From: Selim [mailto:Selim@sawayaeng.com]
Sent: Tuesday, June 18, 2019 8:03 AM
To: 'Ron Dragoo'
Cc: 'SoK@rpvca.gov'; 'Jill Martin'; 'Ara Mihranian'; 'Scott Campbell'
Subject: 2019-06-18 # Tract 50666 # Request for Storm Drain Amendment

Re: **Request to use Forestall Canyon to convey off-site storm water in lieu of the proposed 60 inch Reinforced Concrete Pipe.**

EXHIBIT "A"
TRACT 50666
PRE-DEVELOPMENT
EXISTING STORM DRAIN

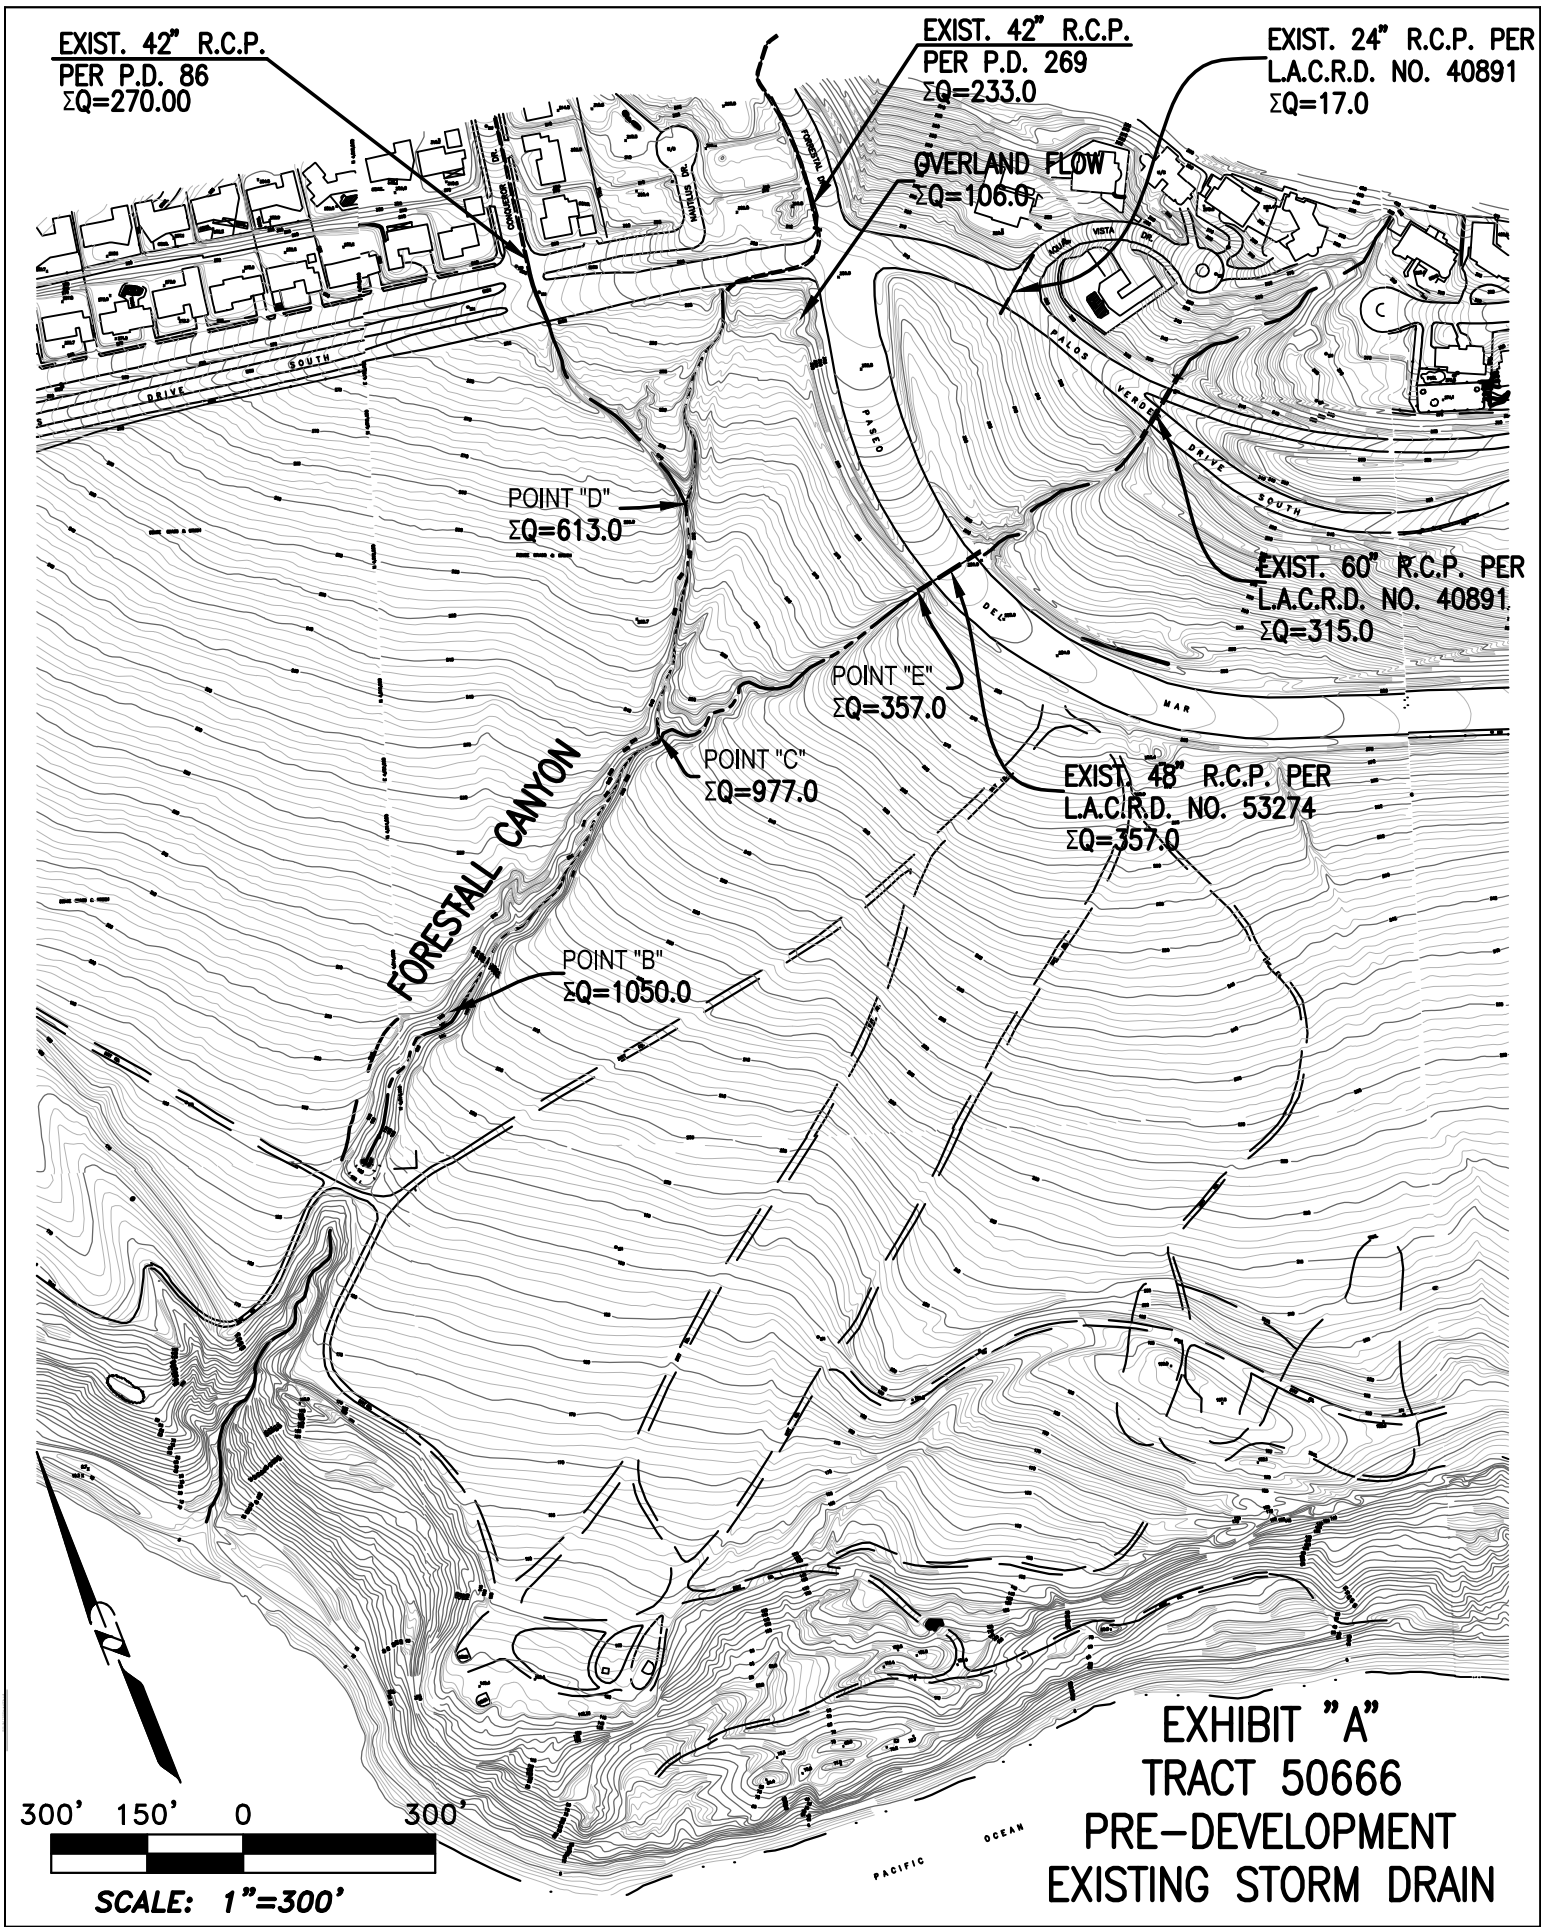
Three different storm drain systems were constructed to outlet to Forestall Canyon to ultimately convey the off-site flow to the ocean. Historically, the flow in Forestall Canyon ranged from 613.0 cfs at Point "D" to 1050.0 cfs. At Point "B" (see Exhibit A).

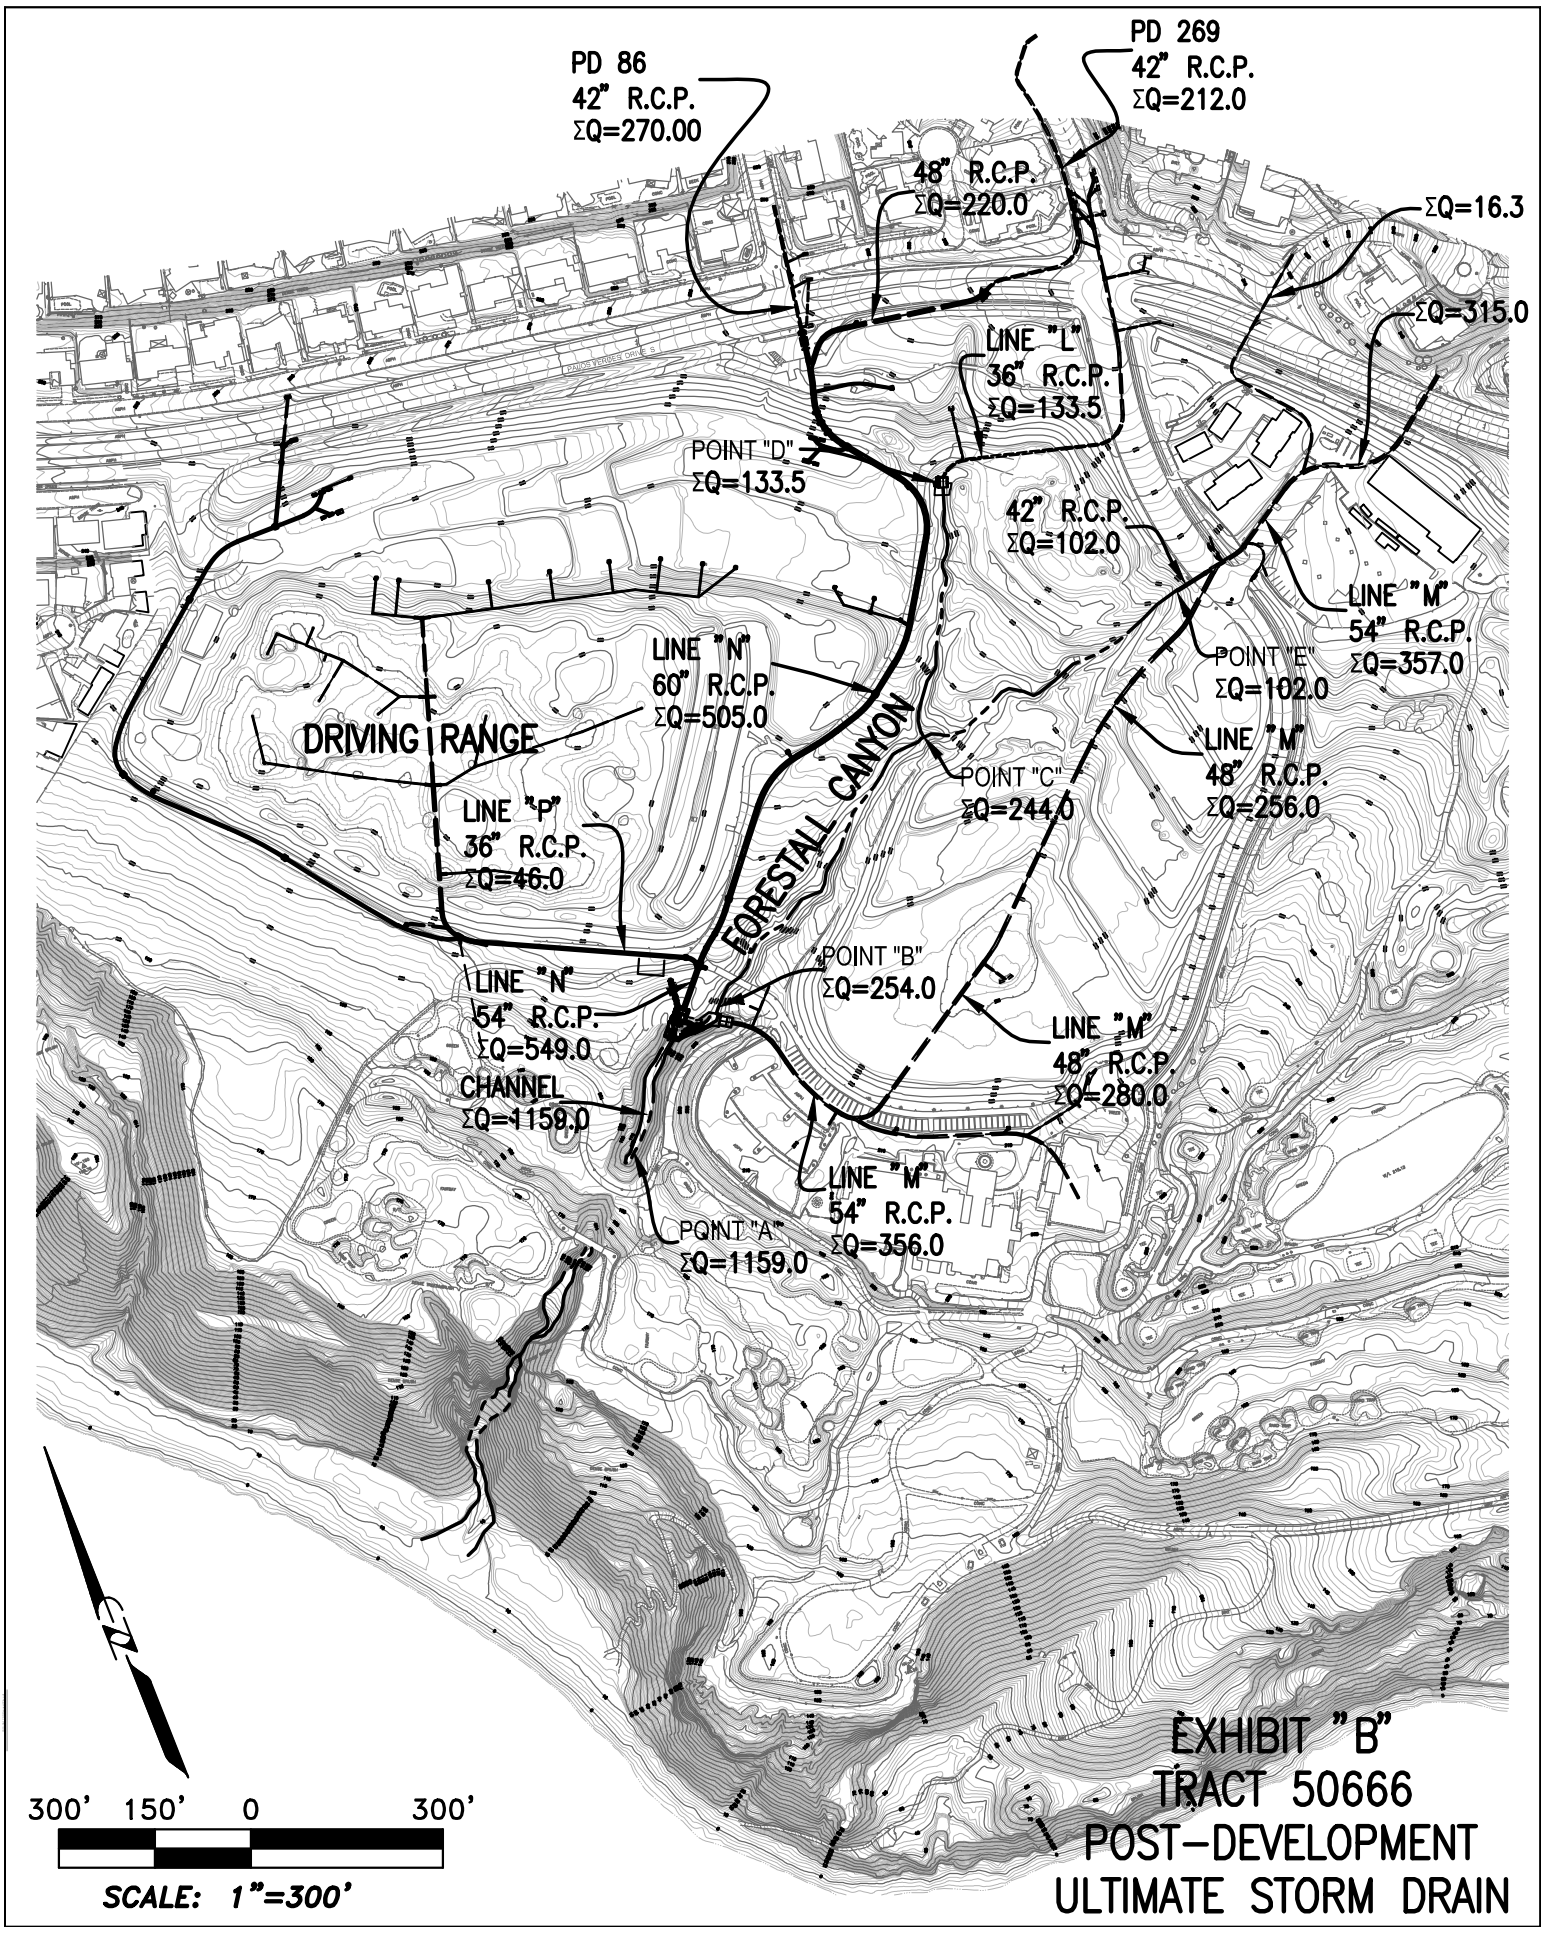
The Drainage Concept of the development as proposed in 2000 and shown on Exhibit "B" was set to reduce / minimize the risk of flooding of the proposed lots from Forestall Canyon. As a result, the flow within Forestall canyon was reduced from 1050.0 cfs at Point "B" to approximately 254.0 cfs. The balance of approximately 800 cfs was to be conveyed back to Forestall Canyon downstream of the proposed lots at Point "B" via a storm drain piping system.

The storm drain systems per PD 86 and PD 269 were existent prior to the development. Line "L" and Line "M" were constructed in 2004 and have been in operation since. The only remaining storm drain lines to be constructed for the development to satisfy the approved Drainage Concept are Line "N" and line "P" (See Exhibit "B").

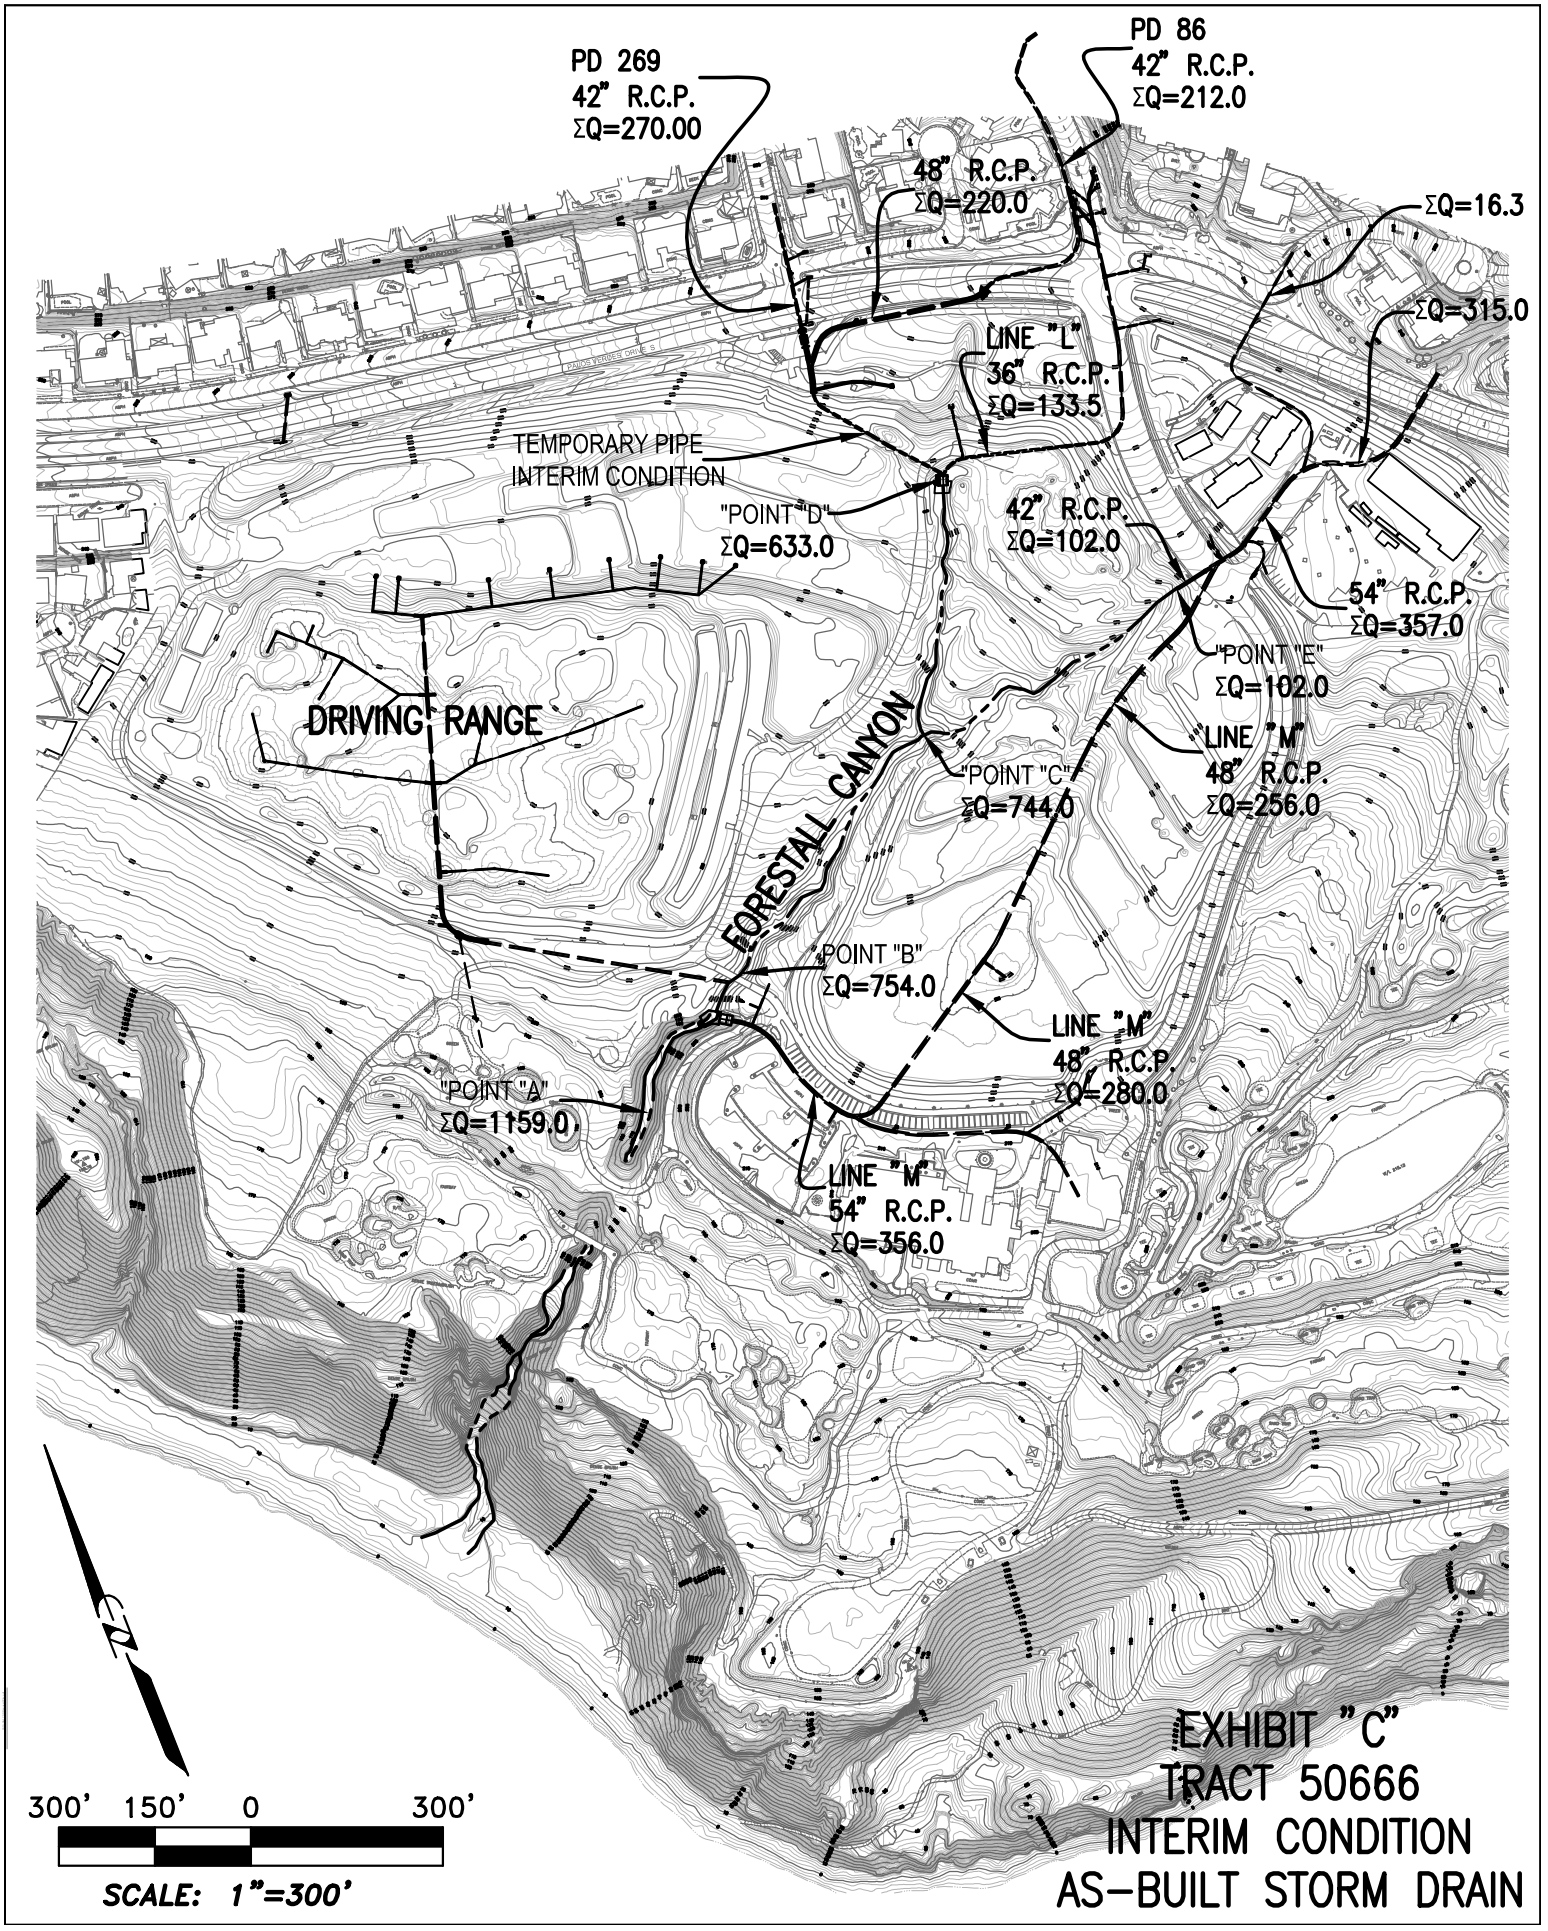
In the interim and until the ultimate drainage system is completed, a temporary pipe was constructed in 2005 to convey the flow of PD 86 and PD 269 back to Forestall Canyon (See Exhibit "C"). Since 2005, (approximately 15 years), the flow within Forestall Canyon between Point "D" and Point "B" has ranged from 633.0 cfs to 754.0 cfs, which is below the historical / predevelopment flow of 1050.0 cfs.
